Interactive comment on “Reducing the ambiguity of karst aquifer models by pattern matching of flow and transport on catchment scale” by S. Oehlmann et al.

Received and published: 29 October 2014

Fig. 1. Three-dimensional view of the model. At the upper boundary, which is hidden to allow a view into the model domain, a constant recharge Neumann boundary condition is applied.

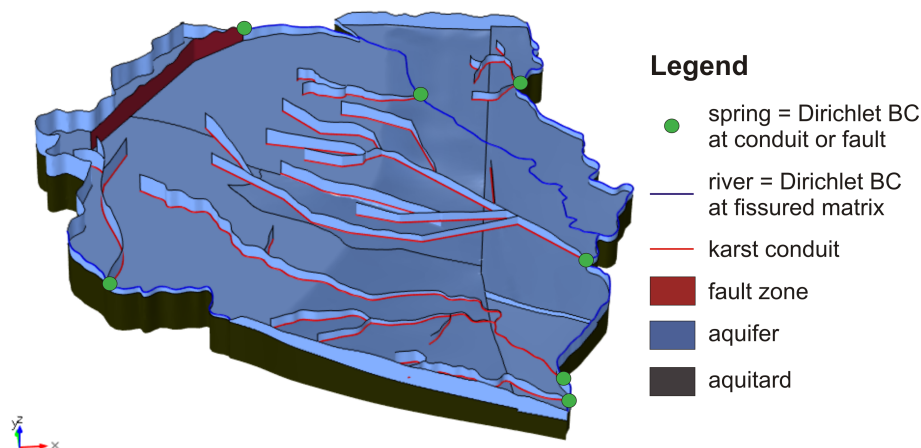
2) P 9289-9292 The modelling domain is rather poorly described. A 3D model or cross-section with model structure & boundary conditions, would help. As this is to some extend given in Oehlmann et al. (2013), published in the same journal, the citation is probably sufficient. However, this depends on the editorial policy.

Answer: We intended to keep the chapter short to avoid lengthening our manuscript by repeating what was already described by Oehlmann et al. (2013). We will adopt your suggestion and introduce a figure showing the model structure and boundary conditions in addition to figure 1 showing the area itself (Fig. 1, this response).
